AMENDMENT TO THE DRAWINGS

REMARKS

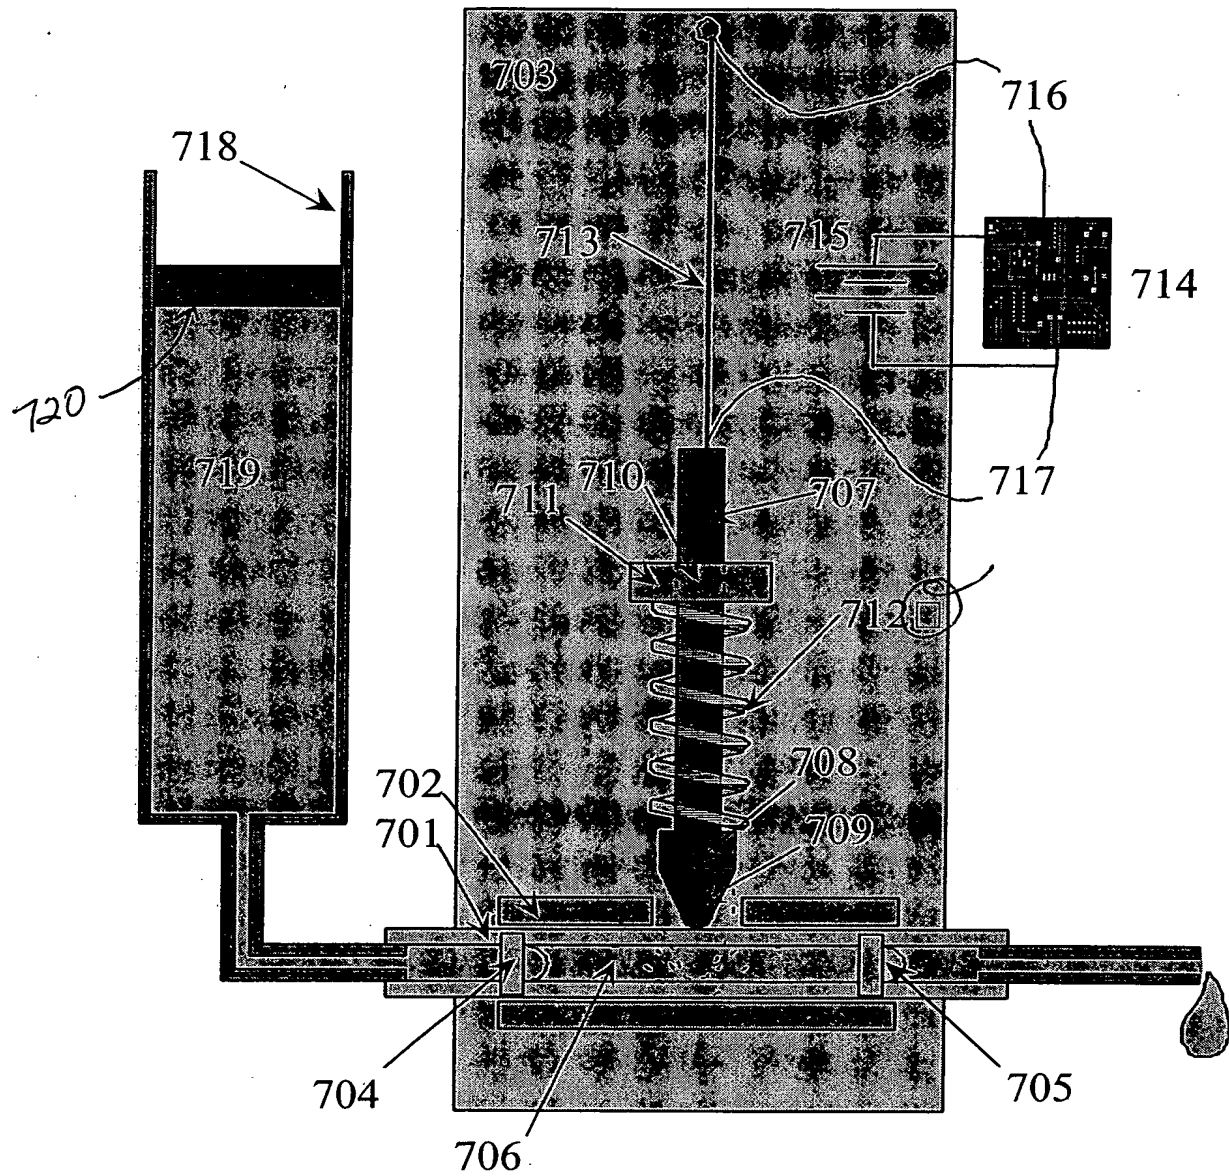
The drawing of Figure 1A has been amended to correct an obvious oversight in the transposition of reference numbers 116 and 118 in original Figure 1A. As amended, the drawing of Figure 1A is consistent with the specification, for example, paragraph [0027] of the specification, and the drawing of Figure 1B. No new matter has been added by virtue of this amendment.

The attached replacement sheet includes changes to Figure 1A. This replacement sheet that includes Figure 1A only replaces the original sheet that includes Figure 1A only. The attached annotated sheet is marked to show the changes made.

Figure 2A

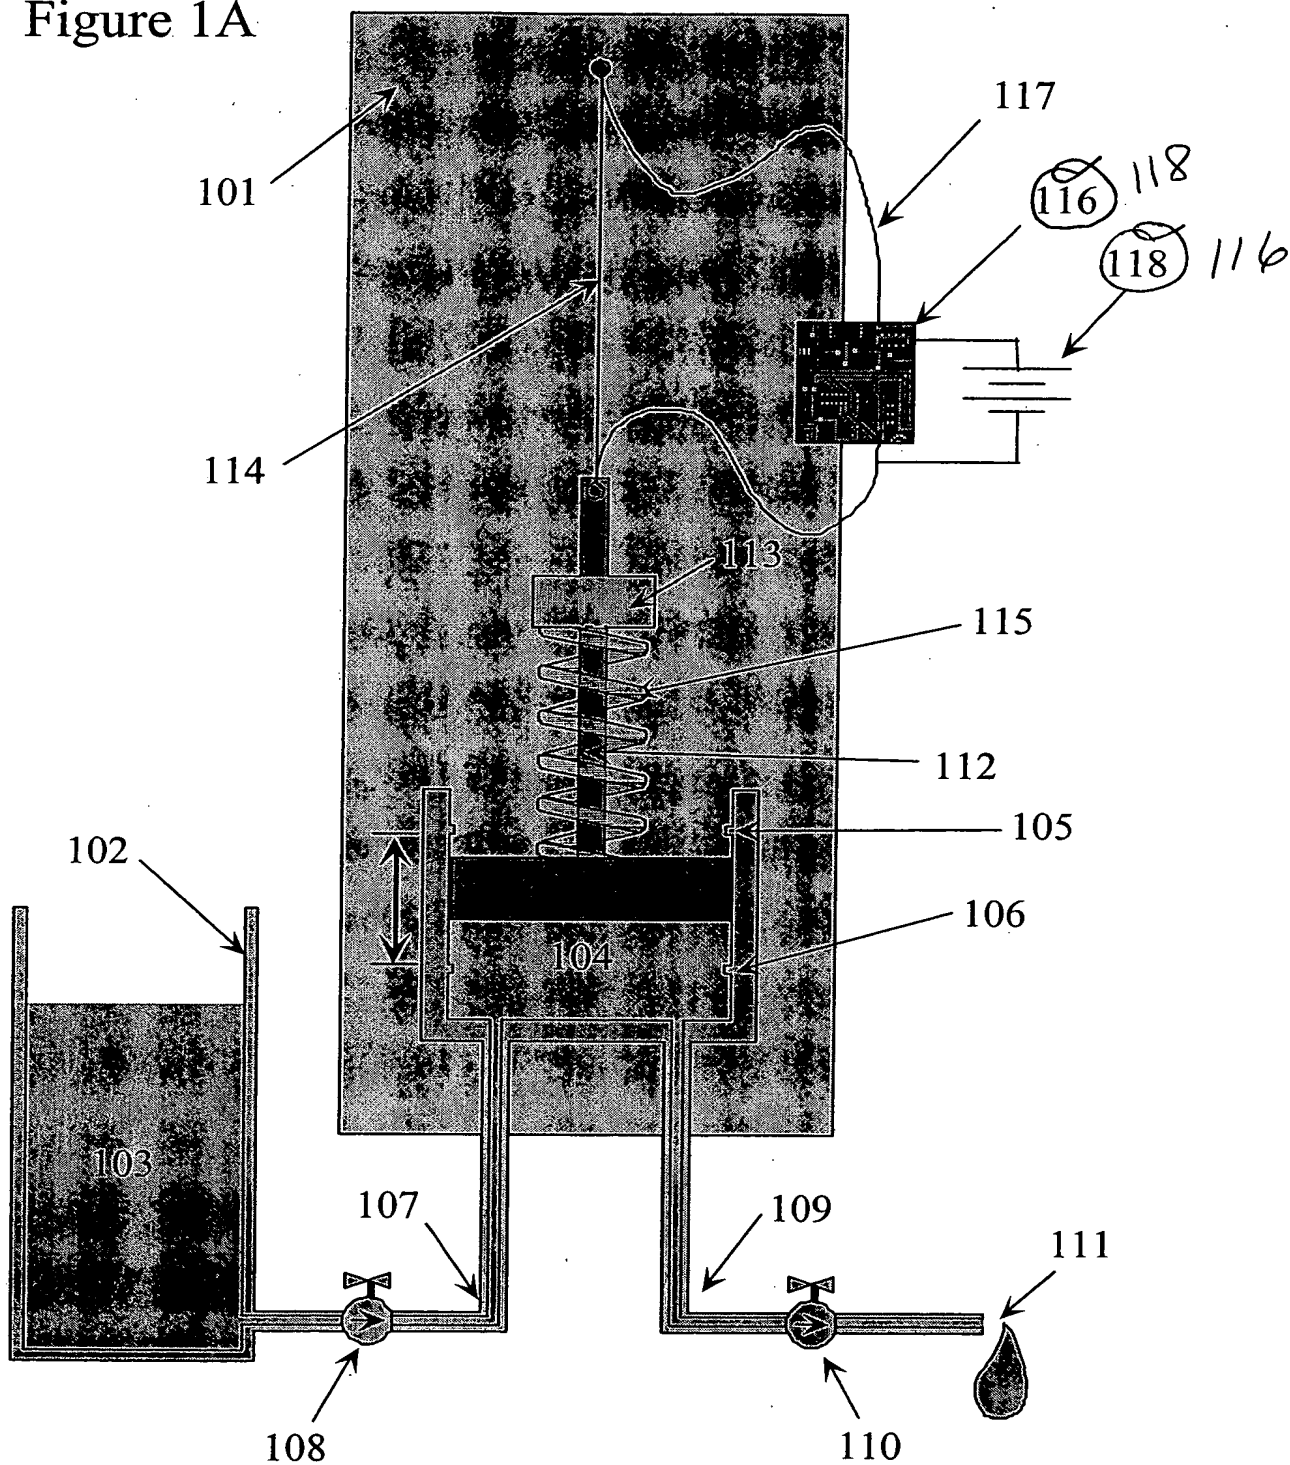
The specification has been amended in paragraph [0037] to refer to reference numbers for the cylindrical bore and the piston discussed in paragraph [0037] and shown in Figure 2A, as is consistent with the replacement Figure 2A, as further discussed herein. No new matter has been added by virtue of this amendment.

The drawing of Figure 2A has been amended to correct an obvious oversight in the appearance of reference number 215 for two different elements shown in original Figure 2A. One appearance of reference number 215 has been removed. As amended, the drawing of Figure 2A is consistent with the specification, for example, paragraphs [0034] and [0037] of the specification, and the drawings of Figures 2B and 2C. The removed reference number 215 has been replaced with the reference number 220 and a new reference 221 has been added, as is consistent with the amendment of paragraph [0037] of the specification, as described above. No new matter has been added by virtue of this amendment.

The attached replacement sheet includes changes to Figure 2A. This replacement sheet that includes Figure 2A only replaces the original sheet that includes Figure 2A only. The attached annotated sheet is marked to show the changes made.
